**CREATION OF EASEMENT OVER SECTION 4295 (216) MCMILLANS ROAD, MARRARA**

REPORT No.: 17CO0015 DB:hd COMMON No.: 265213

**Presenter: Manager Design, Developments & Projects, Drosso Lelekis**

DIA - New Sewage Rising Main  
Review of Proposed Works

**Fig.1 Easement & Existing SPS**

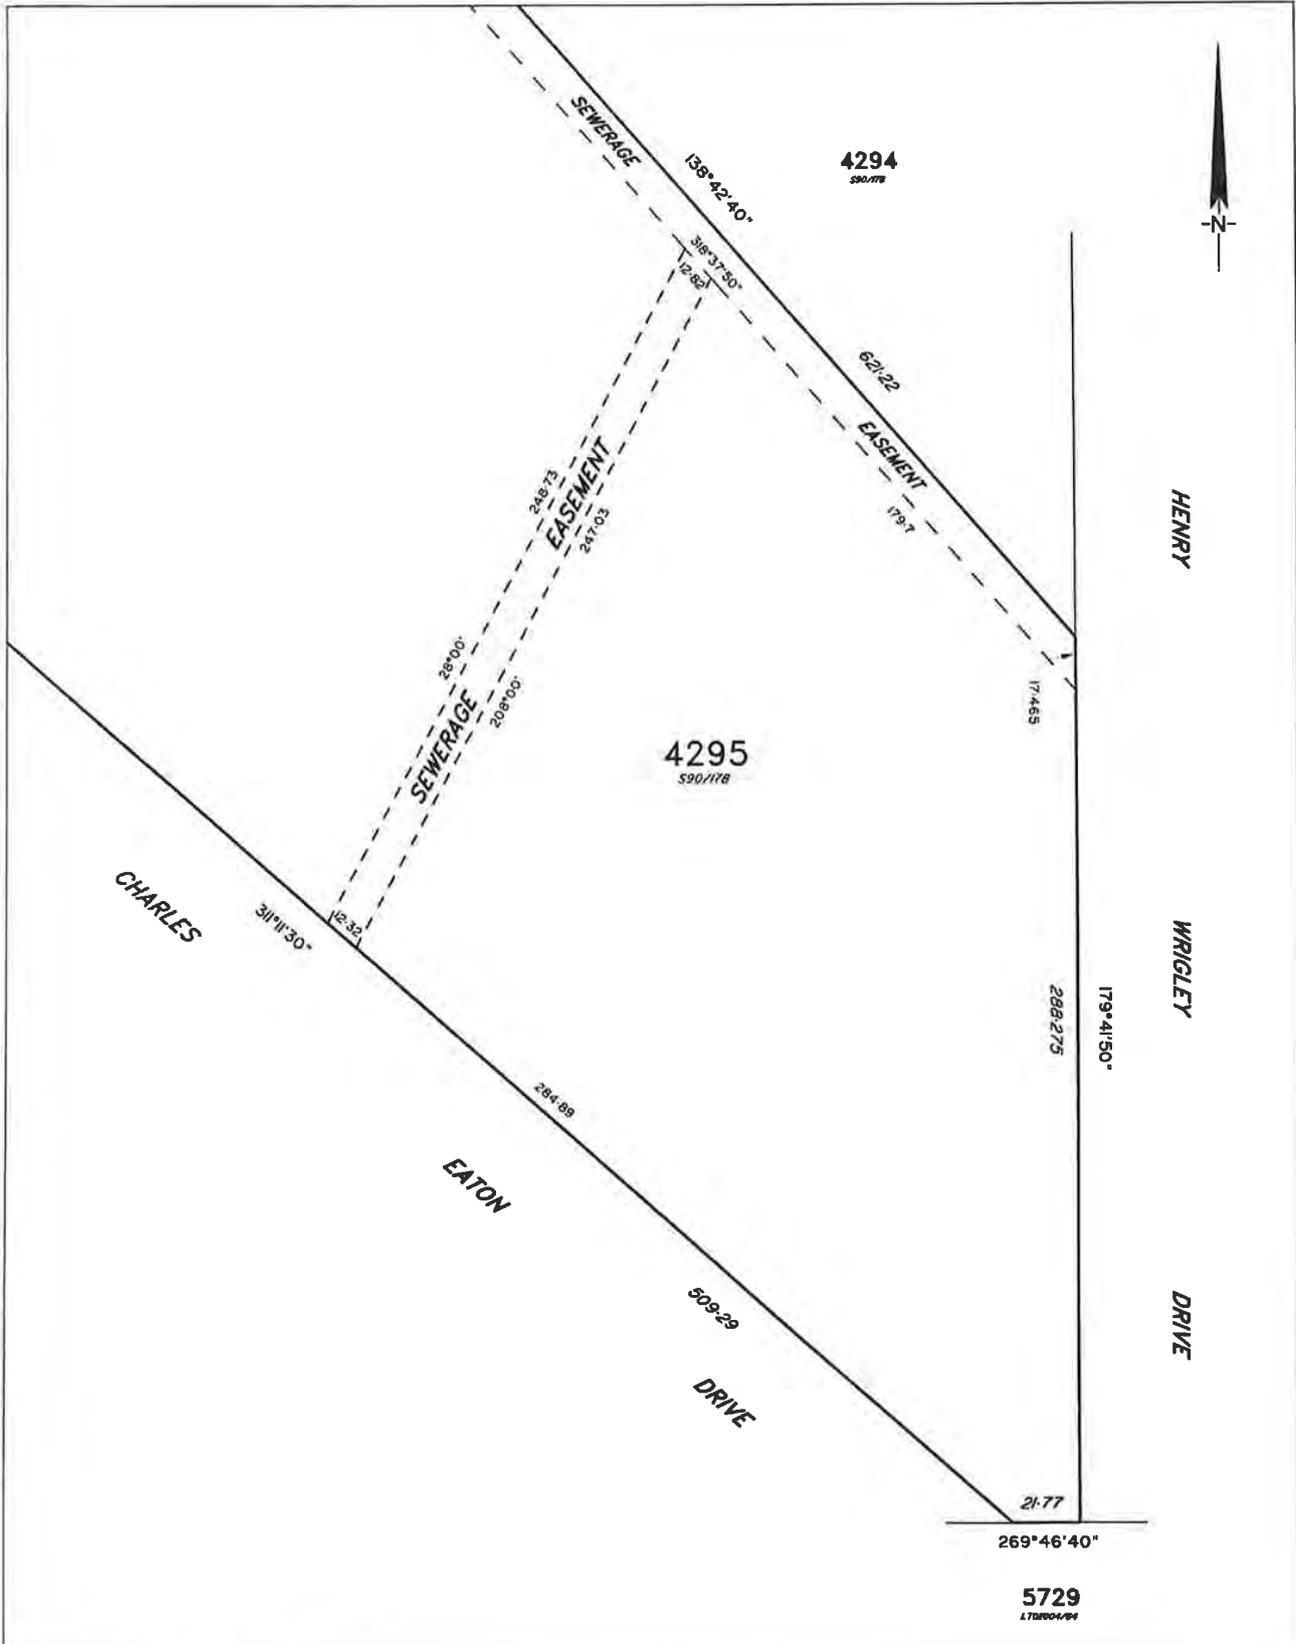
DIA have assessed alternative routes but maintain that the direct route (270m) alongside the current outlet is the best outcome for the preservation of the soon to be conservation zone and DIA. The positioning alongside the current SRM will allow for ease of maintenance providing a direct line of sight from the pump station situated on Murphy Road along the easement. Furthermore the reduction of environmental risk is considerable given the overall length and capacity/volume is at least 2.5 time less than any of the alternatives.

Was to utilise the installed infrastructure along Charles Eaton and go towards McMillans Road. The flow of the sewer is directed towards Murphy Road collection point and has been designed to cater for any and all future development. There would also be the increased risk to encapsulating the soon to be conservation area in more sewer pipe than necessary.

Was to install the second pipe along Charles Eaton in the road reserve and along Henry Wrigley Drive road reserve. This was ruled out also as it is 2.5 times longer (670m) and again would encapsulate a much larger portion of the soon to be conservation area. The capacity/volume of such infrastructure would hold a greater risk to the surrounding area.

**PROPOSED SEWERAGE EASEMENT  
 SECTION 4295 HUNDRED OF BAGOT**

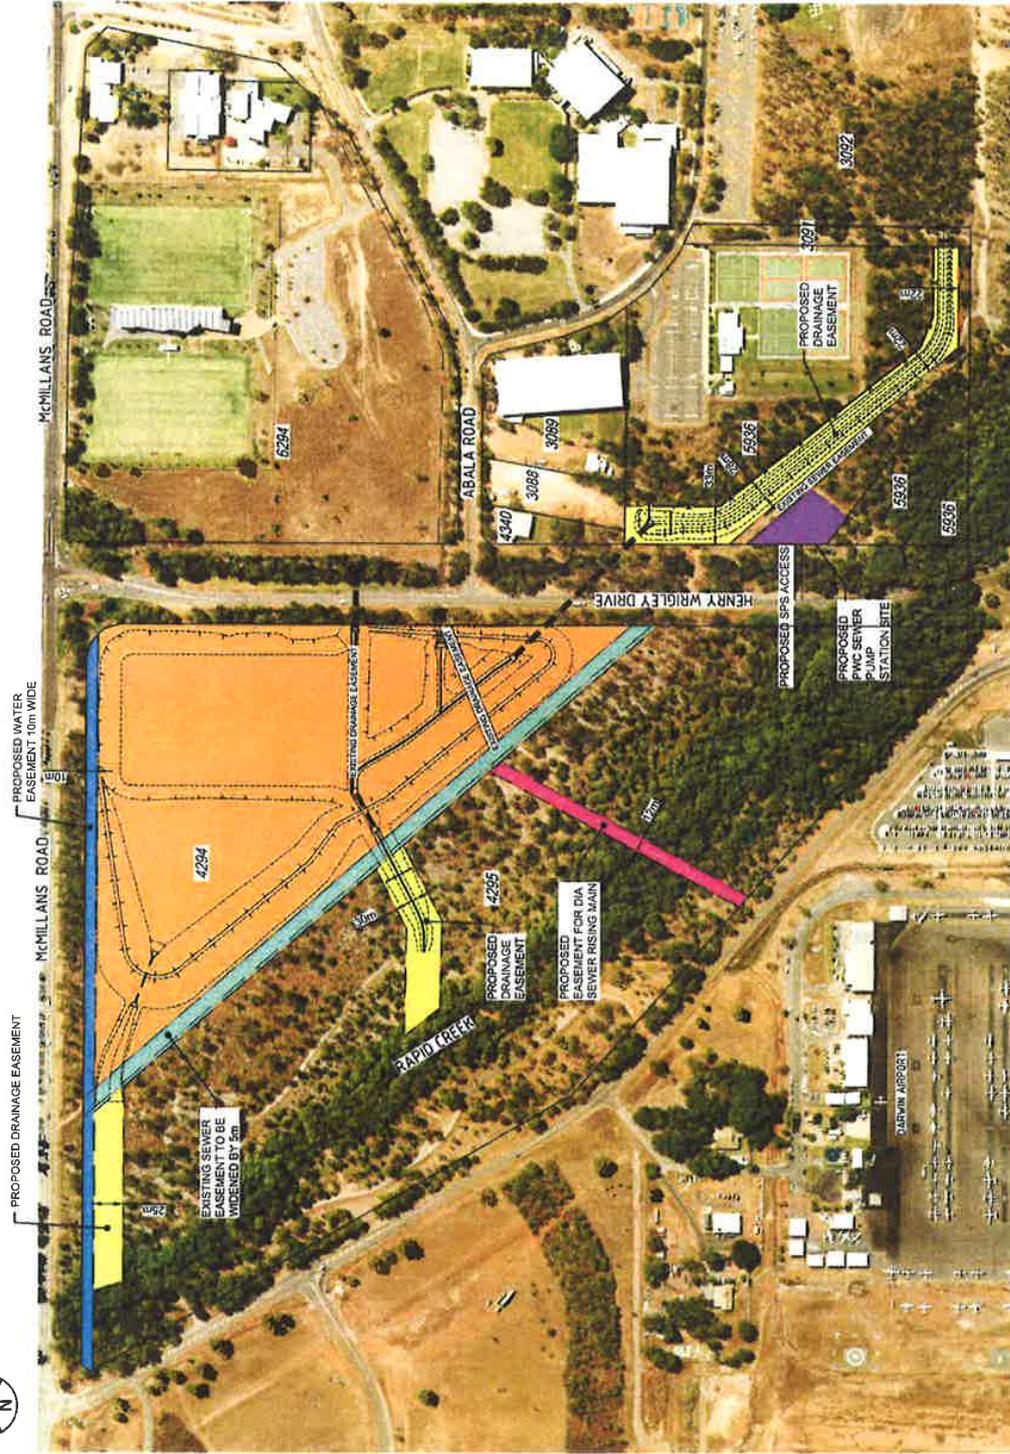
The independent assessment determined that a minimum of a seven metre wide easement would be sufficient to accommodate the existing and future pipes. In considering the request and the assessment, City of Darwin officers consider that an eight metre wide easement would be appropriate.

This recommendation is to doesn't approve the duplication of the existing sewer rising main and grants an eight metre wide easement in favour of the upstream lot with conditions restricting tree removal, access and construction.

- A. THAT Report Number 17CO0015 DB:hd entitled Creation of Easement over Lot 4295 (216) McMillans Road, Marrara, be received and noted.
- B. THAT Council approve the creation of an eight metre wide sewer easement over the existing sewerage infrastructure over Lot 4295 (216) McMillans Road, Marrara in favour of Section 5729 (40) Henry Wrigley Drive, Eaton subject to:

- (ii) the boundary of the easement be offset from the existing sewer rising main by 1.5 metres to allow space within the easement to accommodate a second sewer rising main.
